Re: Questions from the FCC

FCC ID: OQKSAT550
Correspondence Reference Number: 11310
731 Confirmation Number EA95507
Date of Original E-Mail: 01/04/2000

Pursuant to your e-mail concerning Telit Mobile Terminals S.p.A.'s SAT 550 Globalstar systems phone, I am forwarding to you our responses to the items 1-8 and 10-11. The relevant portions of the FCC's e-mail follow with our responses inserted in the appropriate place:

Figure 2.1. Antenna In (Stored)

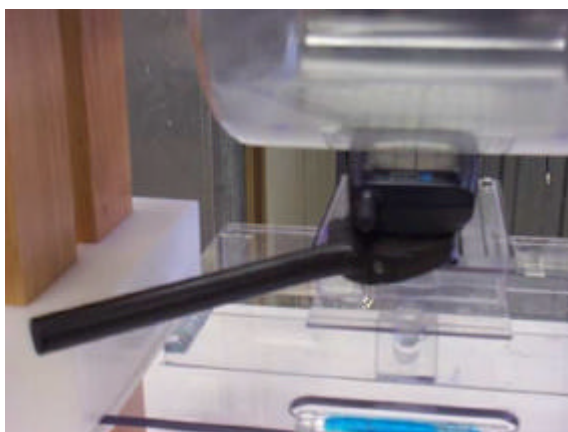
- > 2. Please clarify the antenna IN, OUT, LEFT and RIGHT tilt positions
- > with respect to the device positions allowed by the Uni-Head phantom
- > and the positions supported by a regular head phantom, such as those
- > previously used by the test lab; especially towards the top and back
- > portions of the head(or) top side-wall of the Uni-Head phantom) where
- > relatively higher SAR during normal use would generally be suspected.
- > We need to determine if the Uni-Head phantom is appropriate or
- > acceptable for testing this phone.

Figures 1 through 4 show the Globalstar phone in the four test positions originally used with the UniHead phantom and the CRS robot. In this orientation we can scan 3 cm horizontally into the curved part of the head. (See item 6 below for pictures with the IDX system).

Figure 4.3.

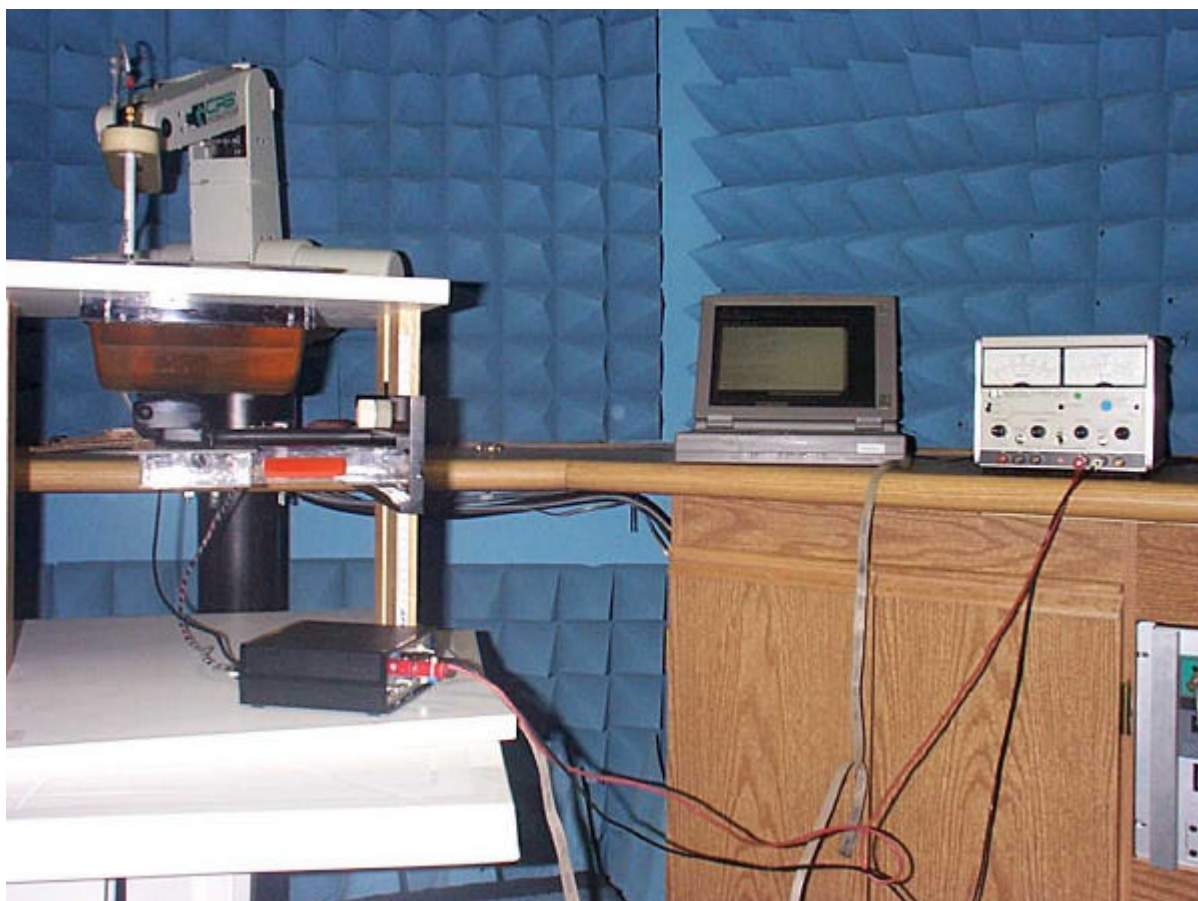
- > 4. Photos in figures 1 and 2 of appendix A in the SAR report are not
- > clear, probably due to re-scanning of the original SAR report. Please
- > re-submit, at least figure 1, to show the satellite antenna
- > positioning during the SAR tests.

The original photos for Figures 1 and 2 are shown below:

Figure 1 shows the phone with the antenna extended and tilted left (relative to looking at the front of the phone) with the UniHead phantom and CRS robot. Figure 2 shows the phone with the antenna stored (in) from above the UniHead phantom, with the liquid removed to increase the clarity of the pictures. Figure 3, below, shows the complete setup that was used for the original measurements, with the external power supply and laptop used to control the operation of the phone. Note that the antenna is extended and tilted to the left. This testing arrangement had been discussed with your
